ADDENDUM NO. 03

Project: Wastewater Treatment Facility Improvements
Walnut Ridge, Arkansas

The Contract Documents dated February 3, 2021, are hereby amended as follows:

Wastewater Treatment Facility Improvements

CRIST ENGINEERS, INC. CONSULTING ENGINEERS LITTLE ROCK, ARKANSAS	
WALNUT RIDGE, ARKANSAS CITY WATER WORKS WWTF IMPROVEMENTS	
INDEX OF SHEETS	
DESIGNED: CAJ	JOB NO: 1618 DATE: MAR 2021 ADD NO. 3
DRAFTED: SBM	SCALE: NOT TO SCALE REF. SHEET G-1
CHECKED: CAJ

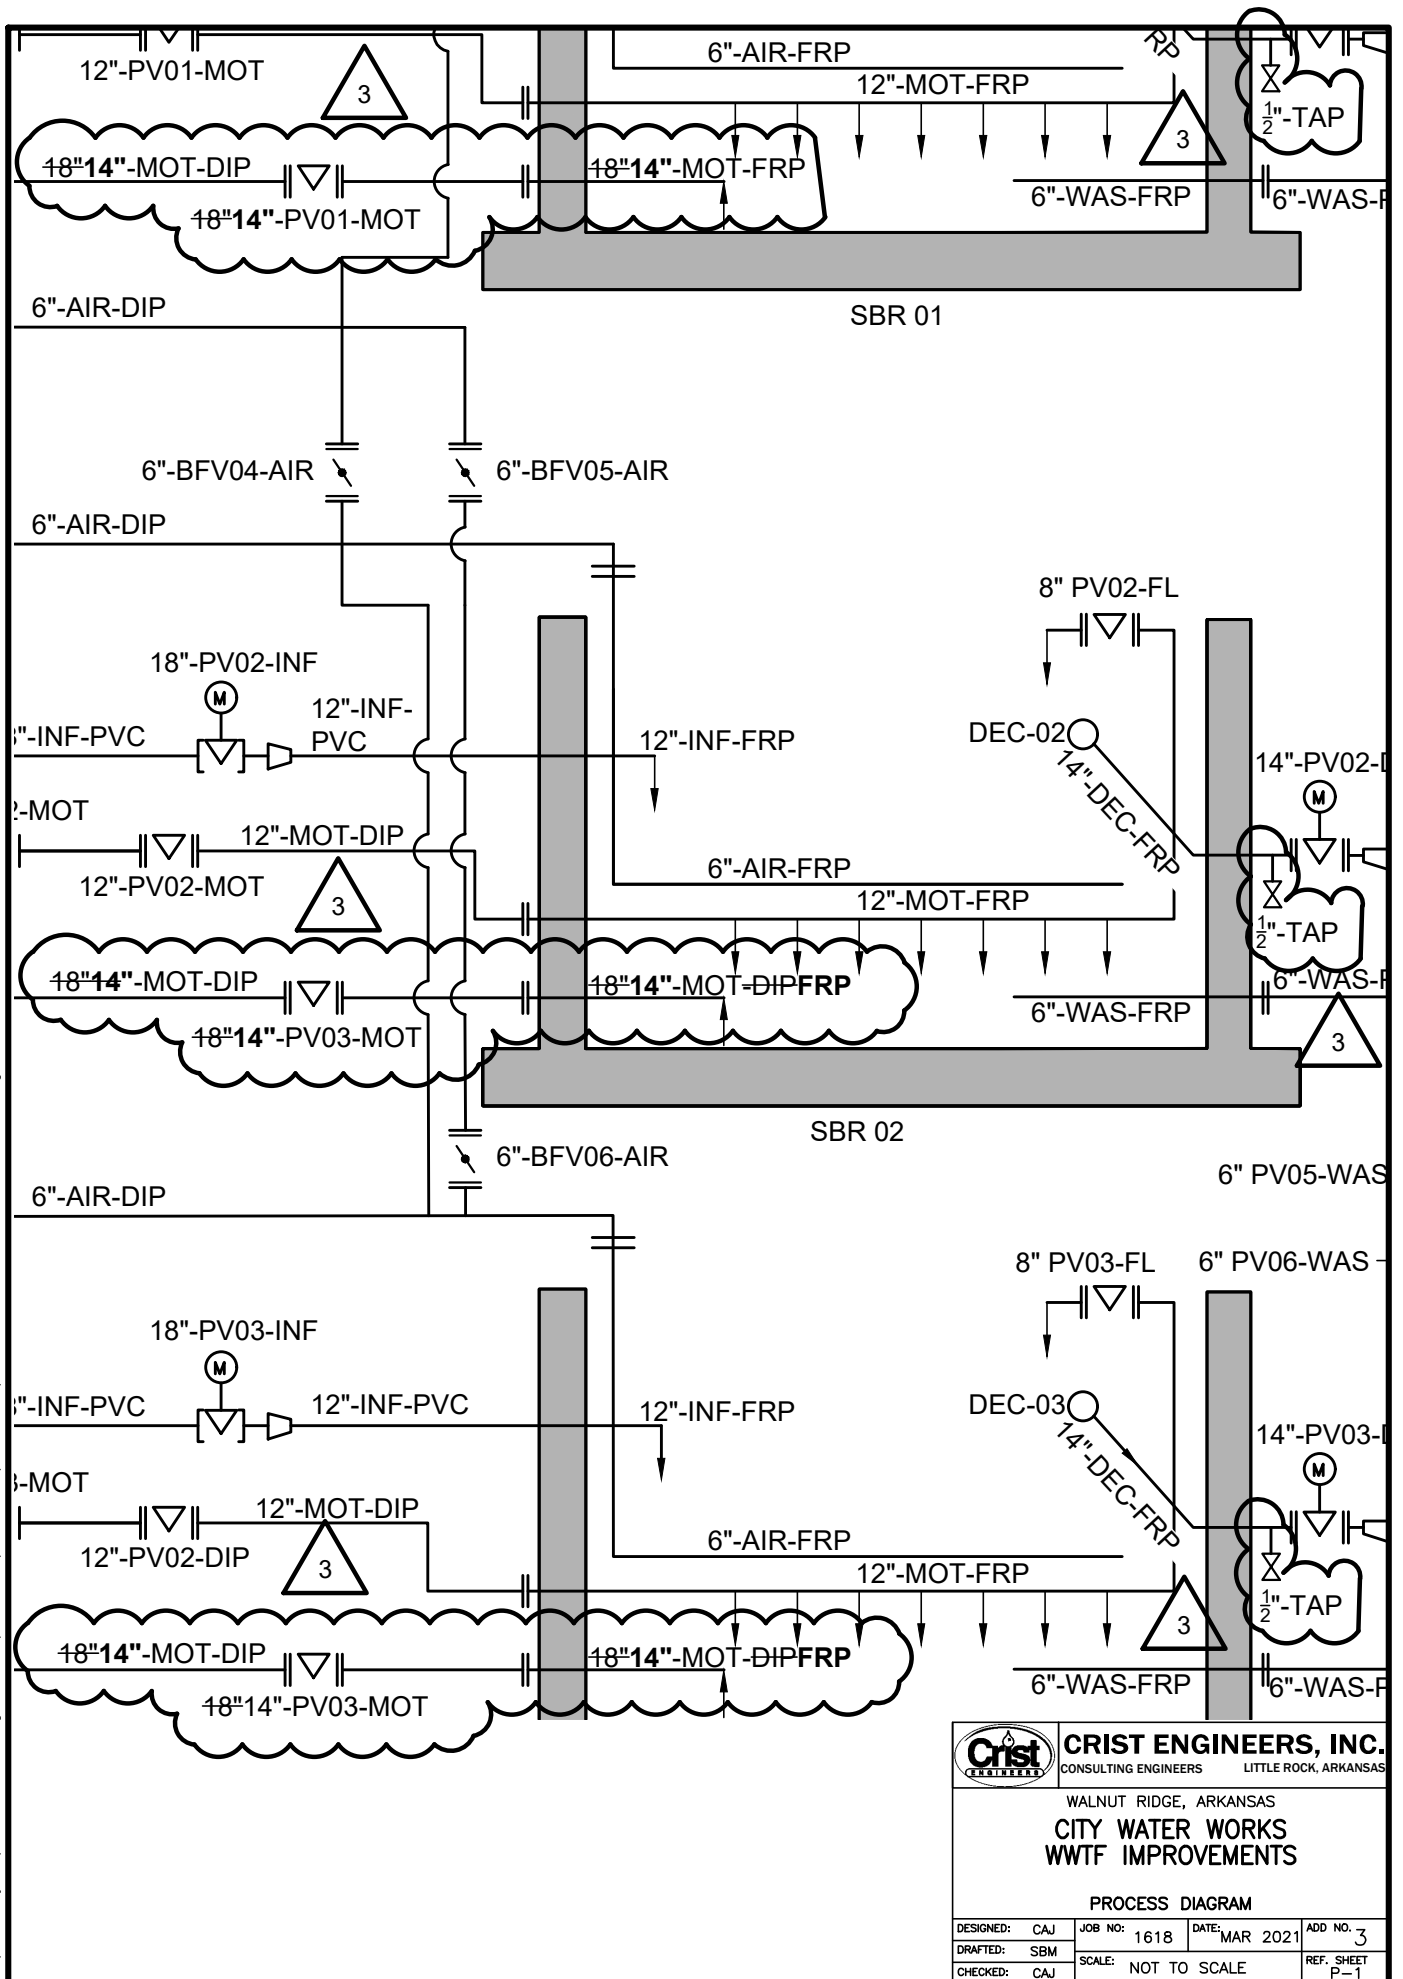
- a. Delete in their entirety all demolition contract drawings listed in the table for Addendum No. 3 (via Drawing G-1), attached hereto.

CRIST ENGINEERS, INC. CONSULTING ENGINEERS LITTLE ROCK, ARKANSAS			
WALNUT RIDGE, ARKANSAS			
CITY WATER WORKS WWTF IMPROVEMENTS			
PROCESS DIAGRAM			
DESIGNED: CAJ	JOB NO: 1618	DATE: MAR 2021	ADD NO. 3
DRAFTED: SBM	SCALE: NOT TO SCALE	REF. SHEET P-1	
CHECKED: CAJ

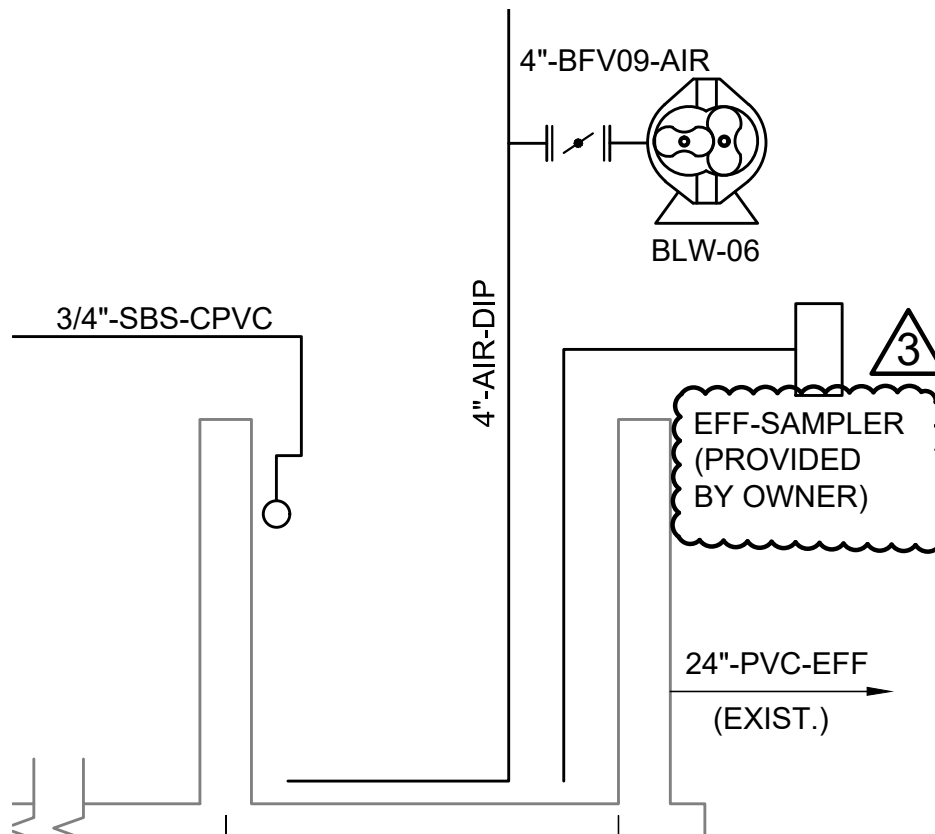
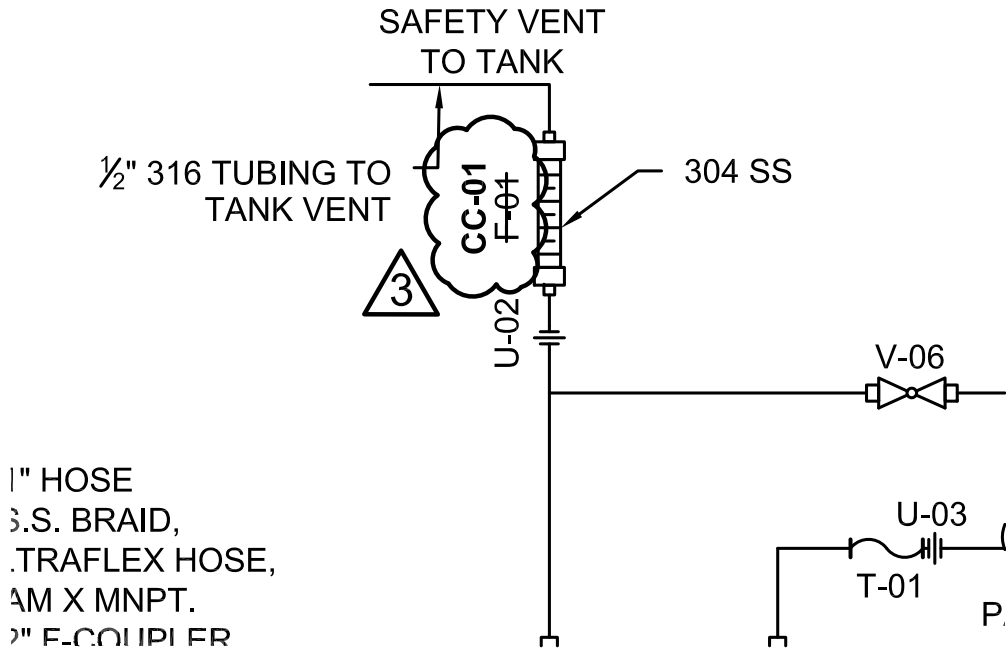
3. Drawing P-1 – Process Diagram:

- a. Modify this drawing as shown on the Addendum No. 3 – Process Diagram, attached hereto.

REV. NO.	DATE	DRWN	CHKD	REMARKS
3	3/02/21	MAB	CAJ	ADDED VALVE AND SLEEVE AT THE WYE CONNECTION FOR OPERATION OPTIONS

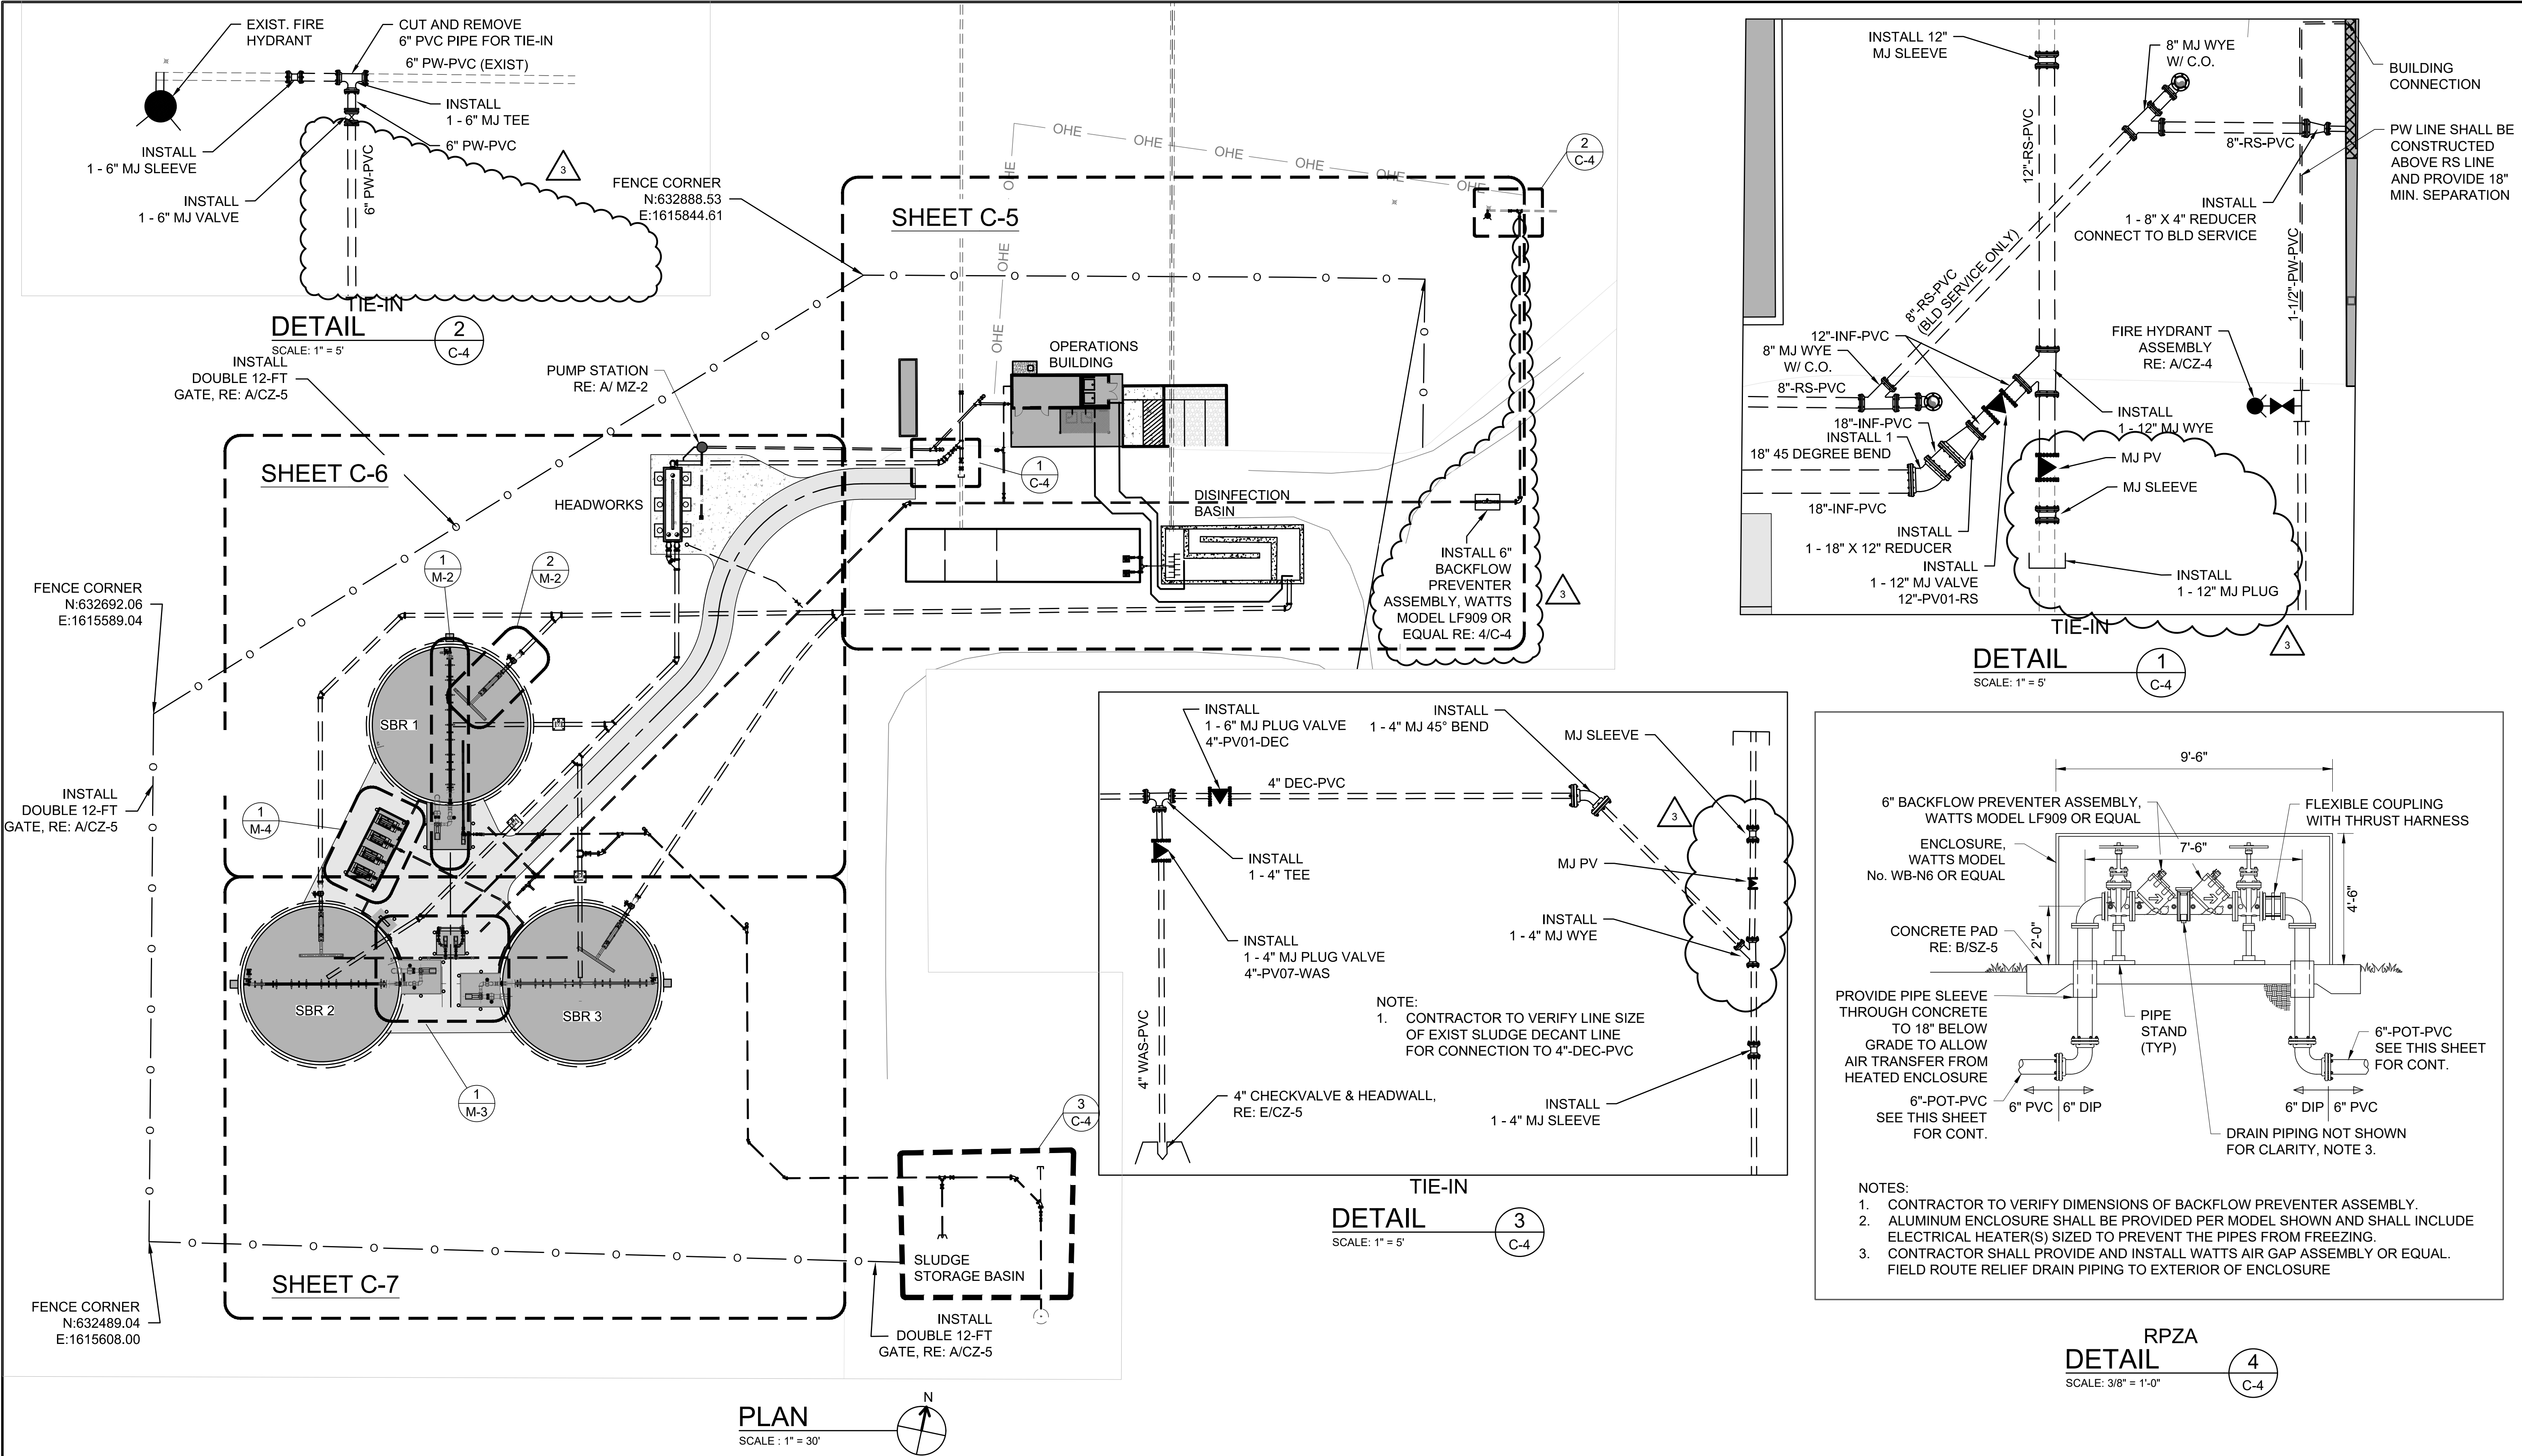
4. Drawing P-2 – PAA Chemical Feed and Potable Water:

- a. Modify this drawing as shown on the Addendum No. 3 – PAA Chemical Feed and Potable Water, attached hereto.

WALNUT RIDGE, ARKANSAS	JOB NO.
WASTEWATER TREATMENT FACILITY IMPROVEMENTS	1618
ADDENDUM #3	SHEET NO.
YARD PIPING PLAN	C-4

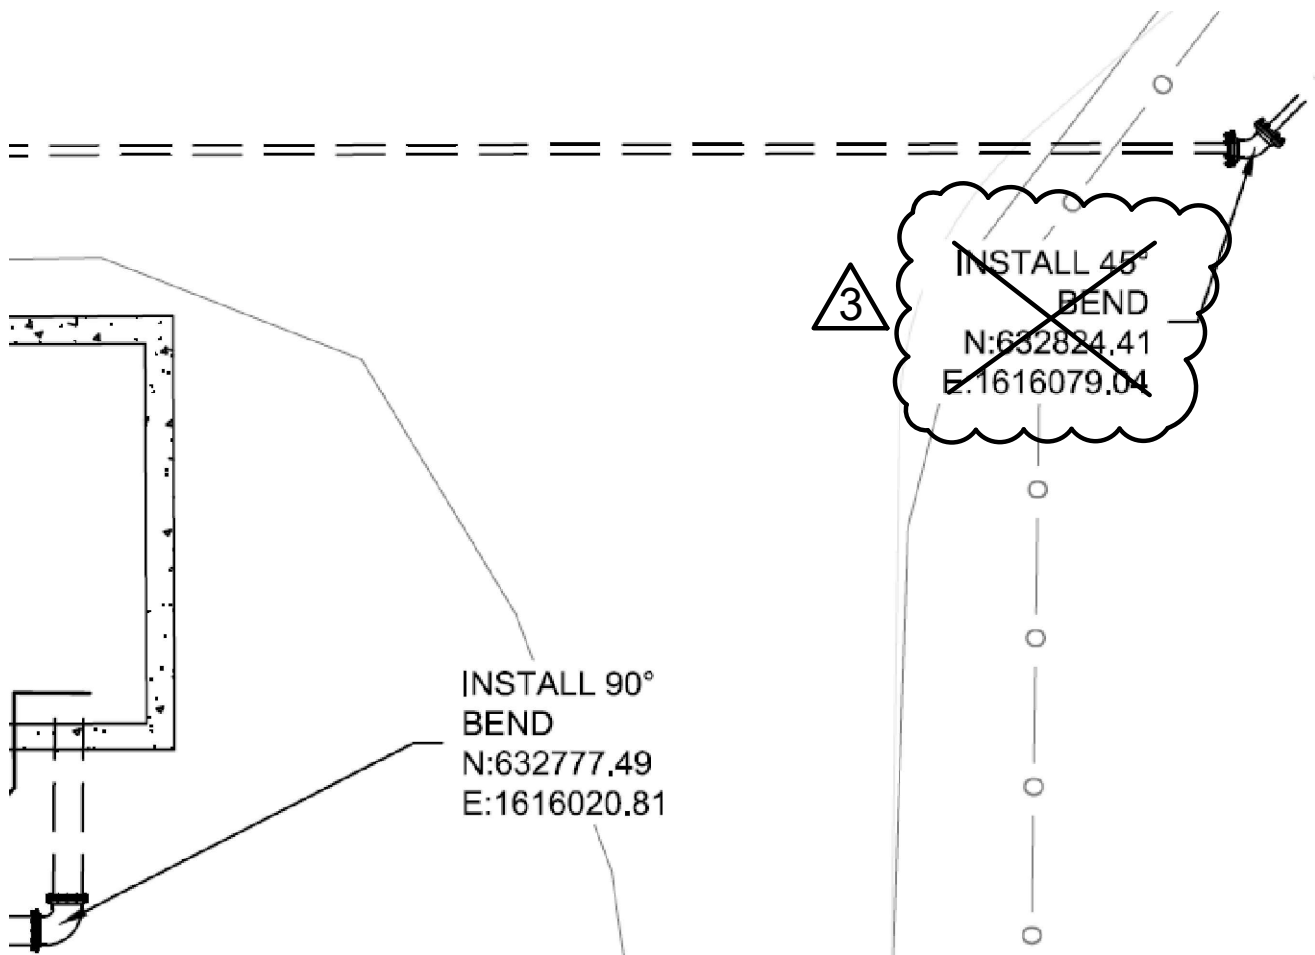
5. Drawing C-4 – Yard Piping Plan:

- a. Modify this drawing as shown on the Addendum No. 3 – Yard Piping Plan, attached hereto.

CRIST ENGINEERS, INC. CONSULTING ENGINEERS LITTLE ROCK, ARKANSAS	
		WALNUT RIDGE, ARKANSAS CITY WATER WORKS WWTF IMPROVEMENTS ENLARGED YARD PIPING I	
DESIGNED: CAJ	JOB NO: 1618	DATE: MAR 2021	ADD NO. 3
DRAFTED: SBM	SCALE: NOT TO SCALE	REF. SHEET C-5	
CHECKED: CAJ

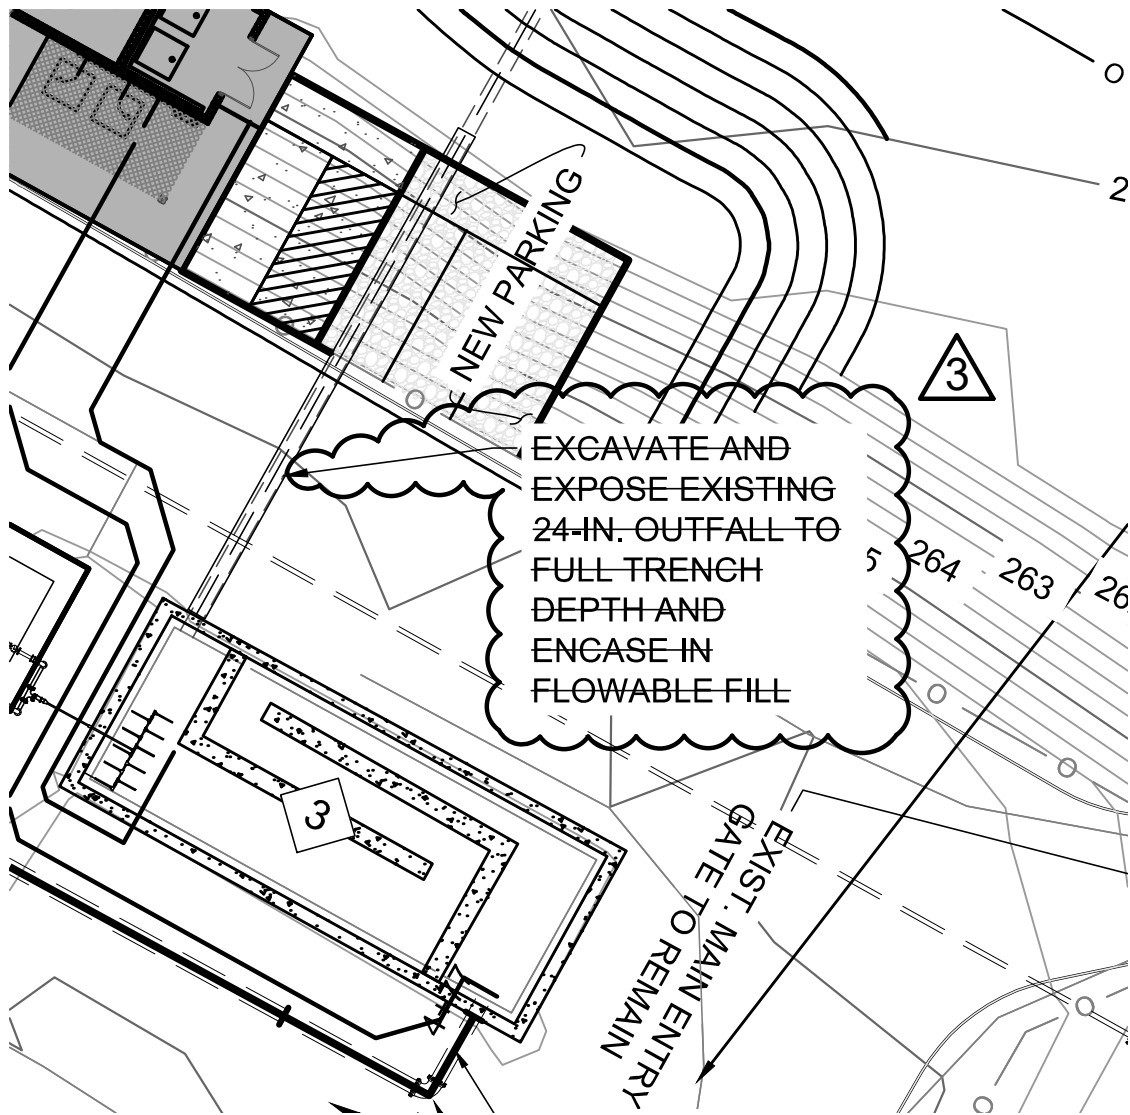
6. Drawing C-5 – Enlarged Yard Piping I:

- a. Modify this drawing as shown on the Addendum No. 3 – Enlarged Yard Piping I, attached hereto.
